VICINITY MAP & GENERAL NOTES
Walker Rd./Jane Lundeen/Pinehurst
Signing and Striping Plan

GENERAL NOTES (CONTINUED)
Walker Rd./Jane Lundeen/Pinehurst
Signing and Striping Plan

TRAFFIC TABULATIONS
Walker Rd./Jane Lundeen/Pinehurst
Signing and Striping Plan

JANE LUNDEEN DR. SIGNING AND STRIPING PLAN
Walker Rd./Jane Lundeen/Pinehurst
Signing and Striping Plan

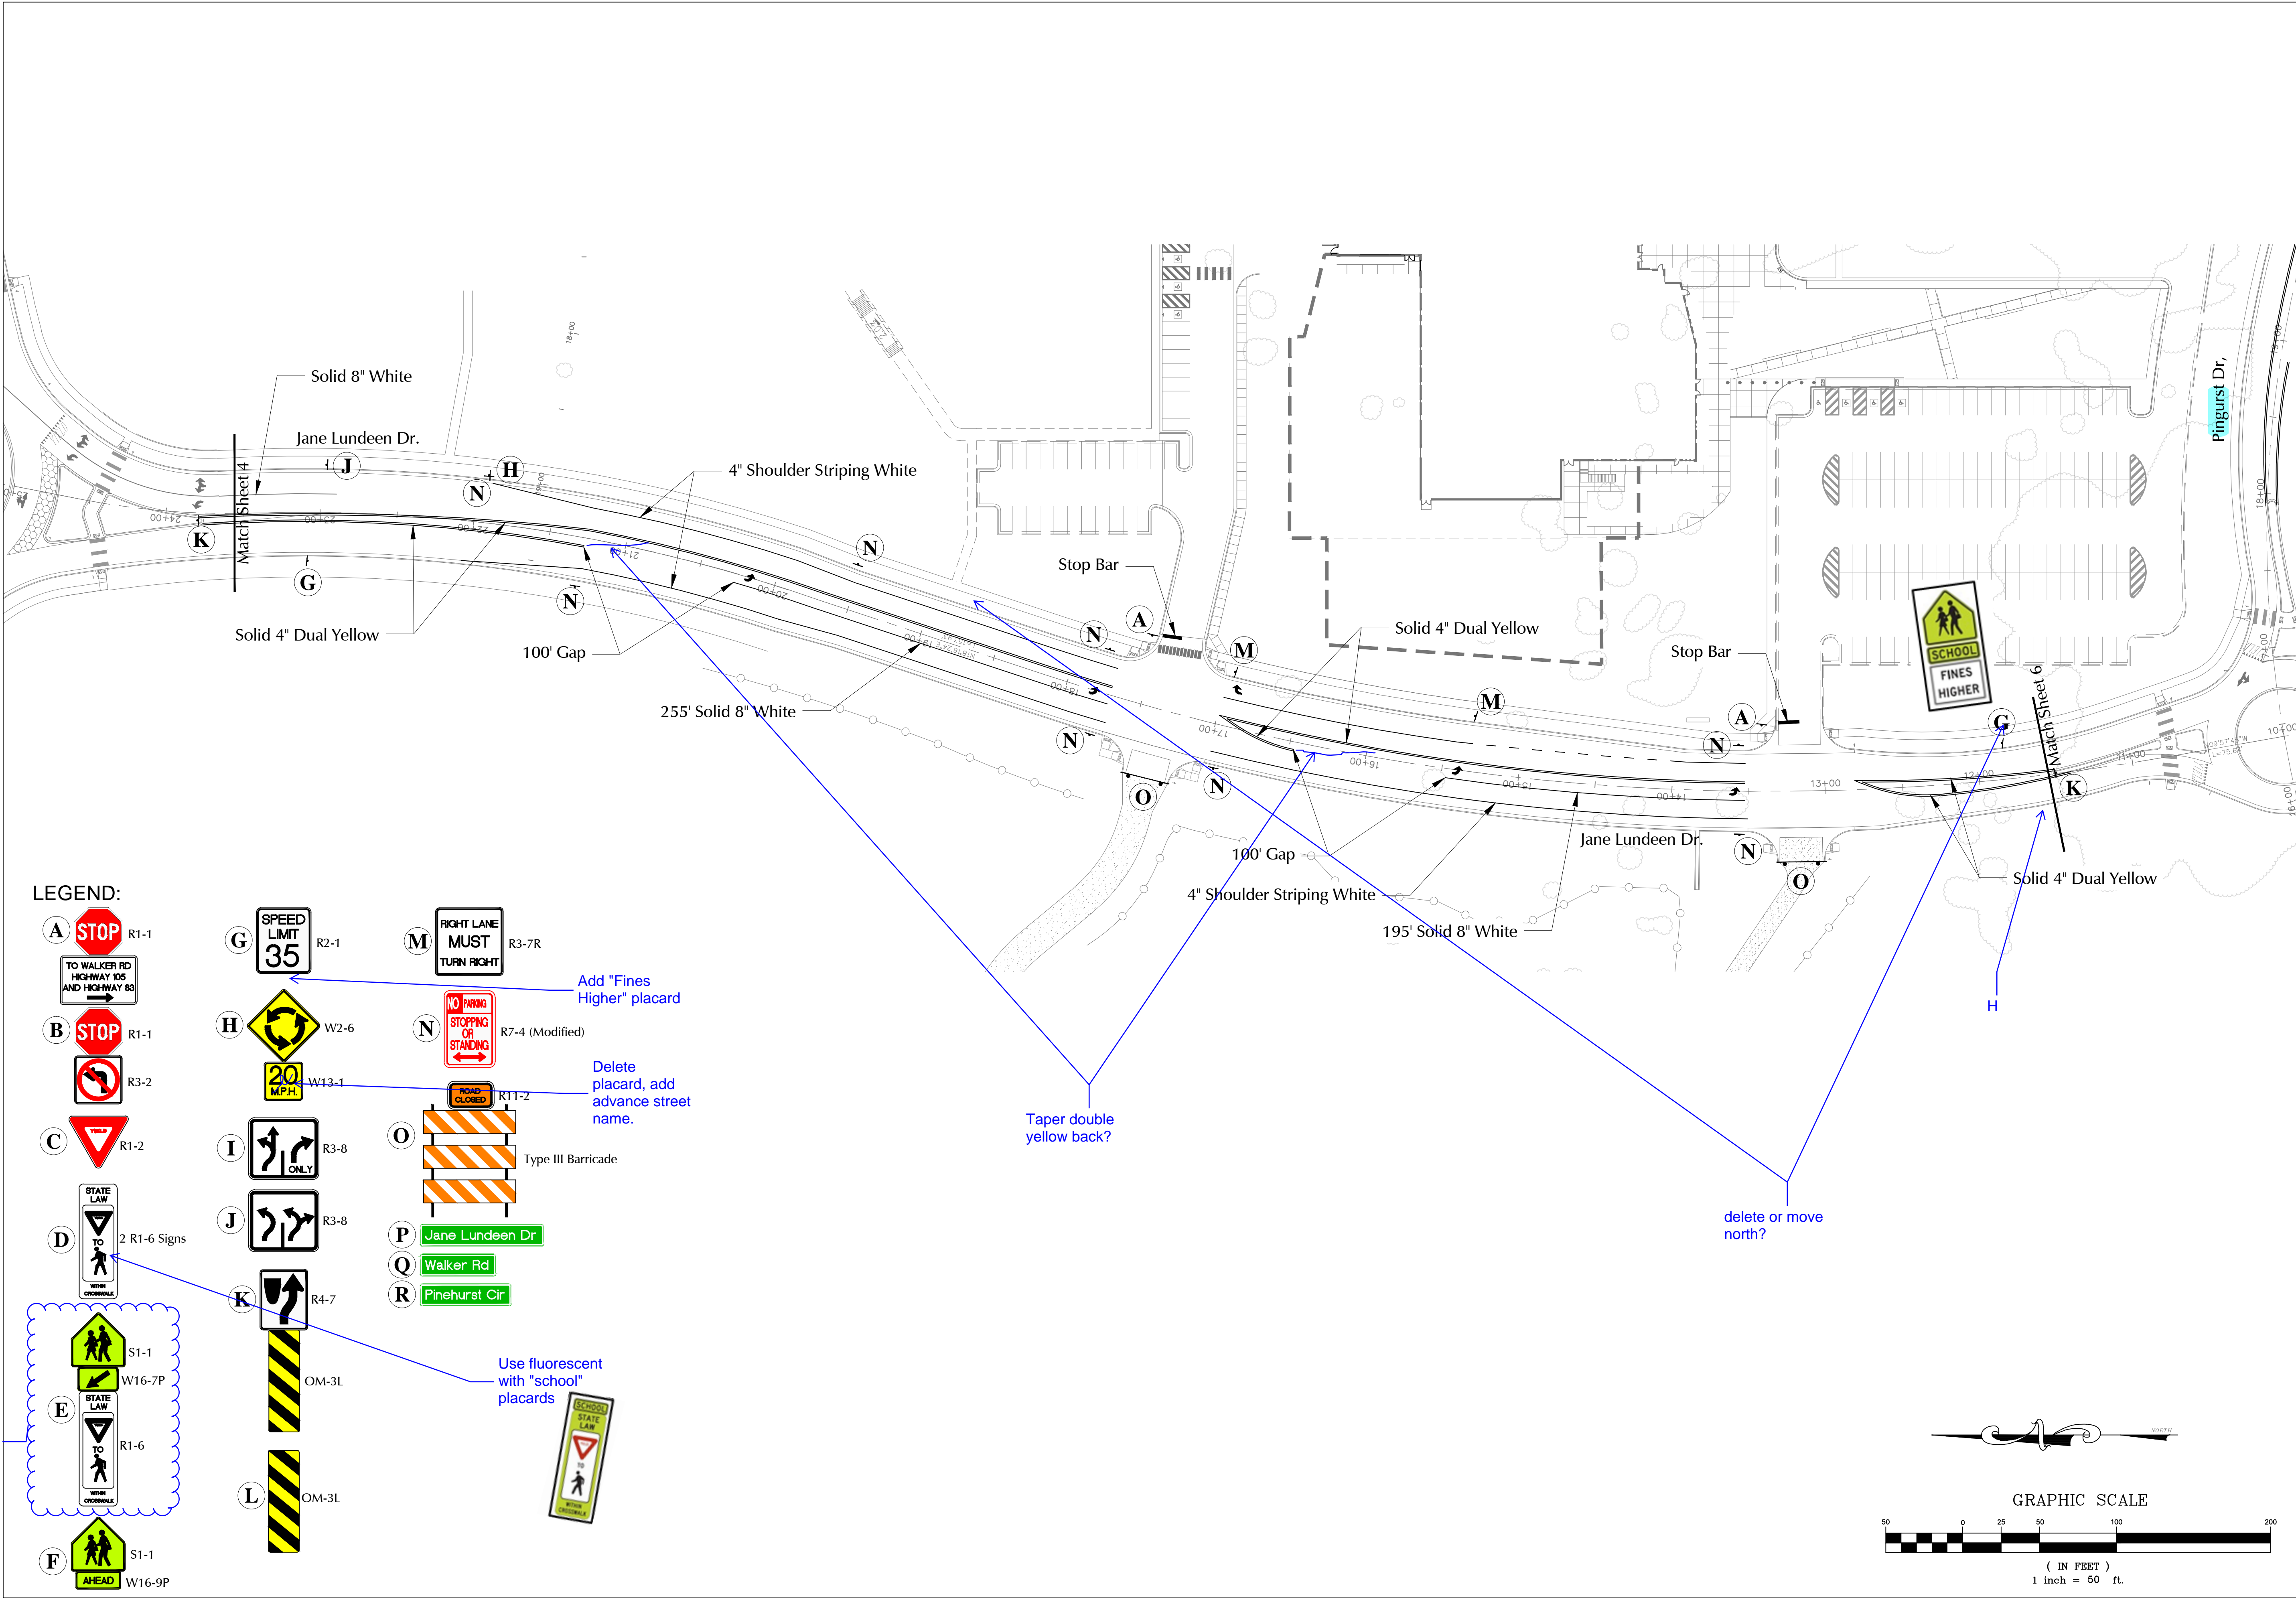
delete - covered by yield sign placement

PINEHURST DR. SIGNING AND STRIPING PLAN
Walker Rd./Jane Lundeen/Pinehurst
Signing and Striping Modifications Plan

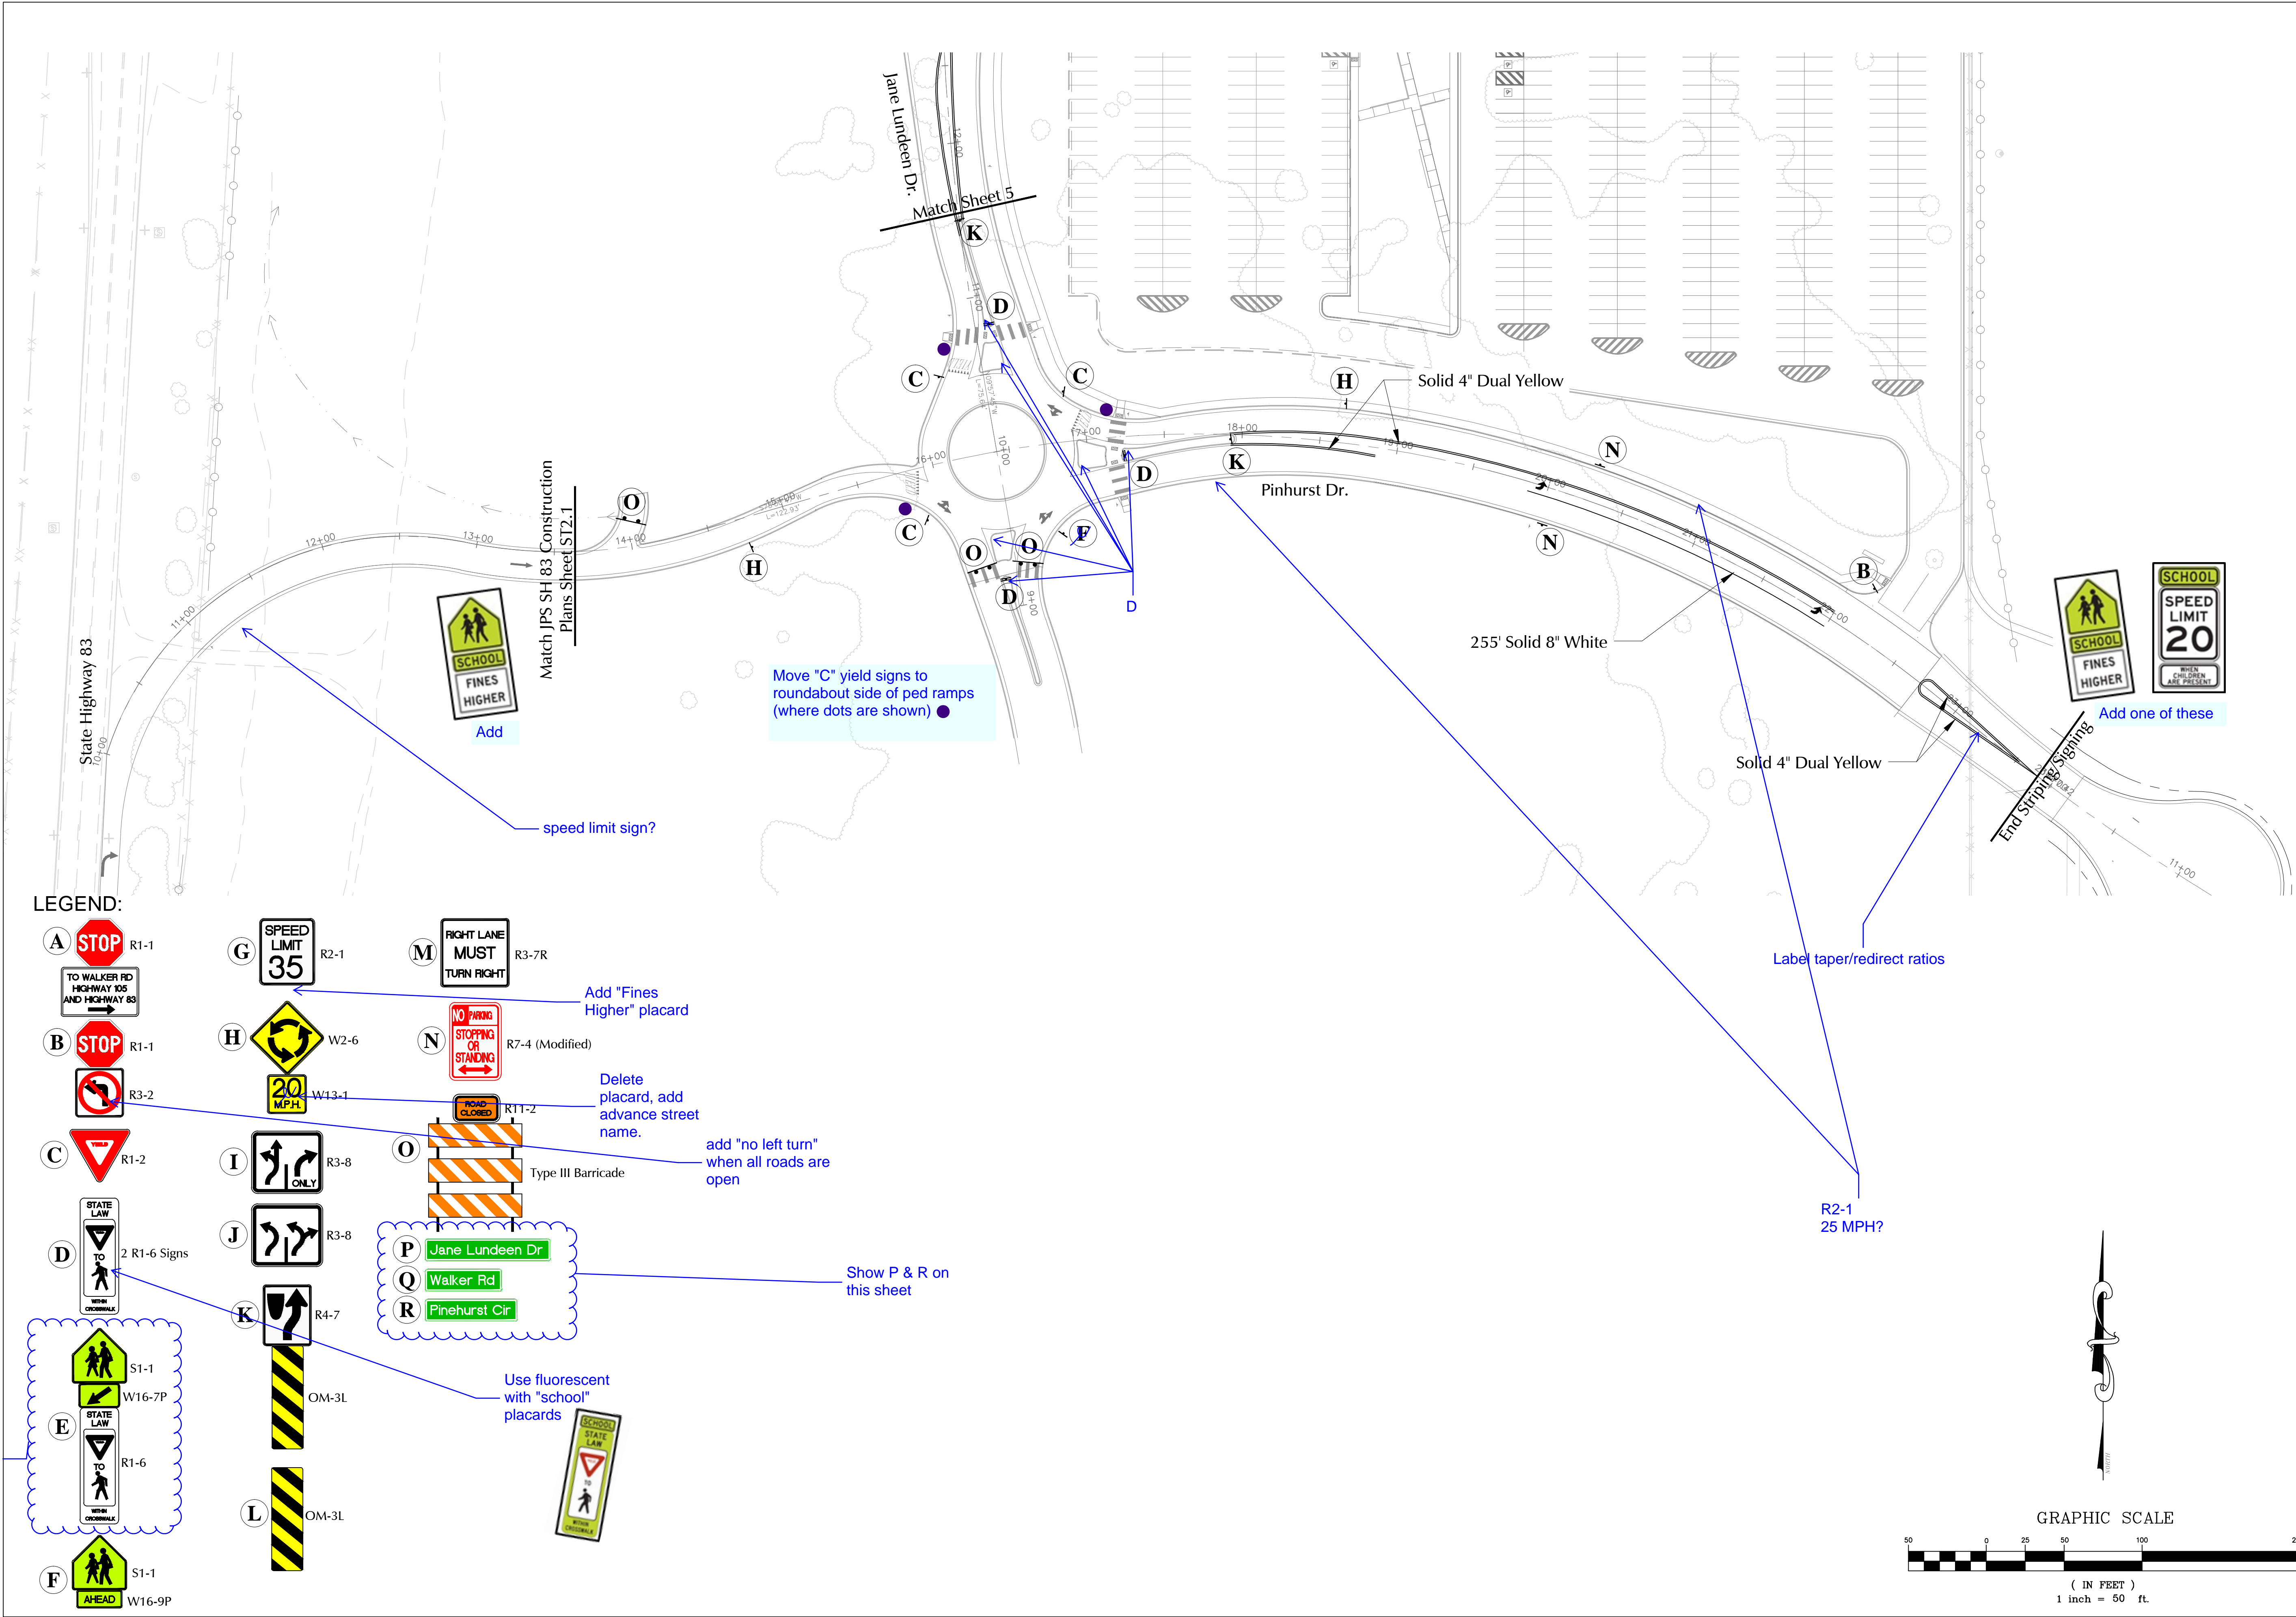
Add "Fines Higher" placard

Delete placard, add advance street name.

Taper double yellow back?

delete or move north?

Use fluorescent with "school" placards

Use fluorescent with "school" placards

delete - covered by yield sign placement

add "Fines Higher" placard

Delete placard, add advance street name.

add "no left turn" when all roads are open

Show P & R on this sheet
